PNG (BD) Ltd (Extension 2)

10 December 2024

Finish Goods Shed: The structure is a single-storied prefabricated steel shed.

Observation 01: Lack of building permit (Finish Goods Shed).

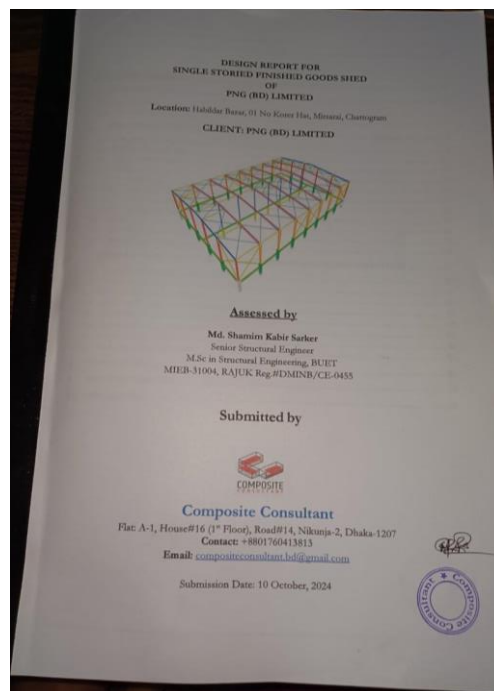
Description: During inspection, no building permit was found on-site. The building engineer is required to collect the building permit from the local authority and submit it to RSC.

Observation 02: Inconsistency in the design report (Finish Goods Shed).

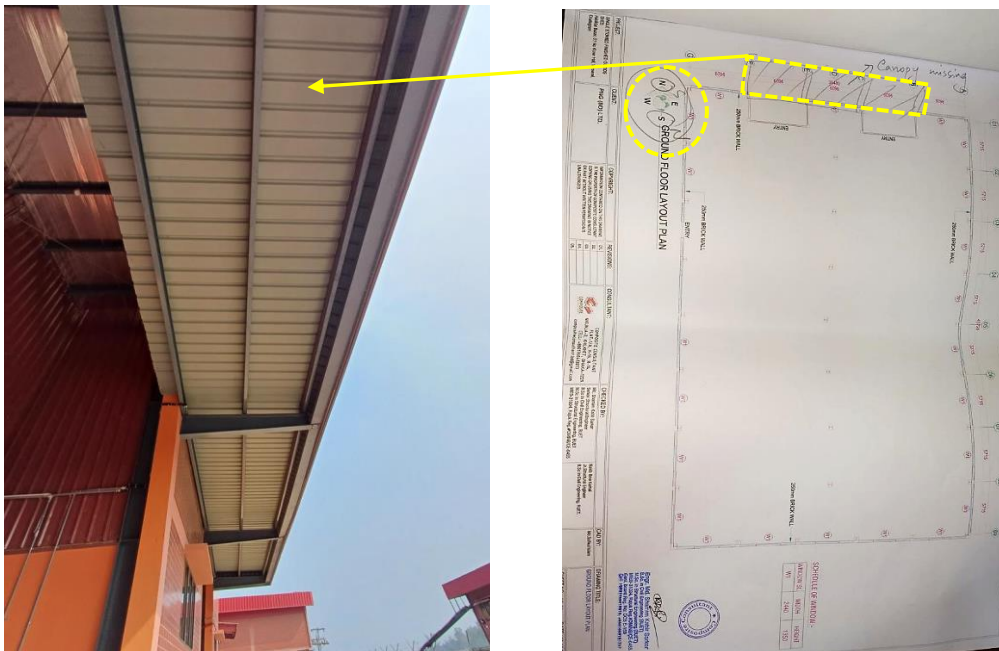
Description: In the design report, no connection adequacy or member adequacy check for the canopy members was provided also canopy part was not included in the design report. The building engineer is required to revise the design report incorporating the connection and member adequacy check for the canopy portion and submit the EA documents to the RSC for detailed review.

2.	Inconsistency in the design report (Finish Goods Shed).	The building engineer is required to revise the design report incorporating the connection and member adequacy check for the canopy portion and submit the EA documents to the RSC for detailed review.	within 6 weeks
